# SERVICE BULLETIN NO. MSB315-62

TWIN ASTIR	S/N	3000 – 3291
TWIN ASTIR TRAINER	S/N	3088 – 3291 (with suffix „T“)
G 103 TWIN II	S/N	3501 – 3729
G 103A TWIN II ACRO	S/N	3544 - 34078 (with suffix „K“)
G 103C TWIN III ACRO	S/N	as of 34101
G 103C TWIN III	S/N	36001 - 36014

**ATA-Code:** N/A  
**C of G release hook**

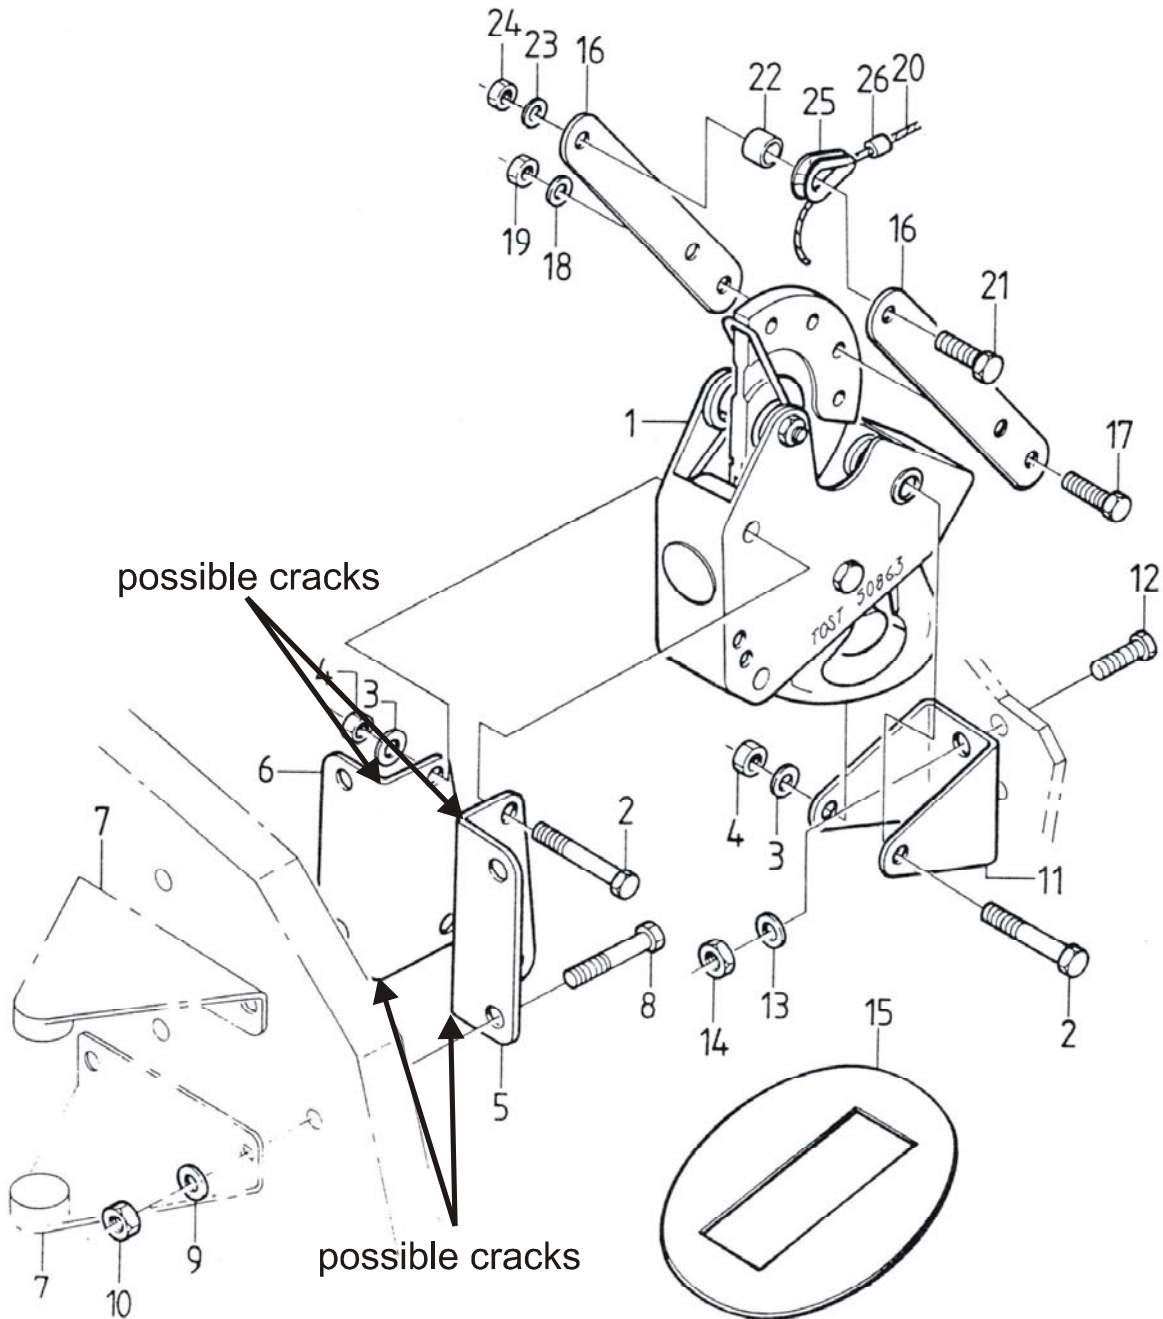
After long time of operation (i.e. towing using the C of G release hook) cracks at the forward C of G release hook attachment brackets might occur.

**Caution:** Illustration below is only for G 103A TWIN II ACRO ! For other models a different arrangement is possible !

**1.8.1** The attachment brackets P/N 103-2235.03 and 103-2235.04 or 103B-2360.01 and 103B-2360.02 must be checked for cracks as follows:

- remove rear seat
- check the brackets for possible cracks, refer to illustration on page 2 (if necessary use mirror and pocket lamp)

- remove rear seat
- remove L/H and R/H instrument panel cover
- remove **front** attachment of the C of G hook (item 2, 3, 4), loosen rear attachment (item 12, 13, 14)
- remove attachment brackets (page 2, item 5 and 6)
- install new brackets P/N 103B-2360.01/2 and 103B-2360.02/2
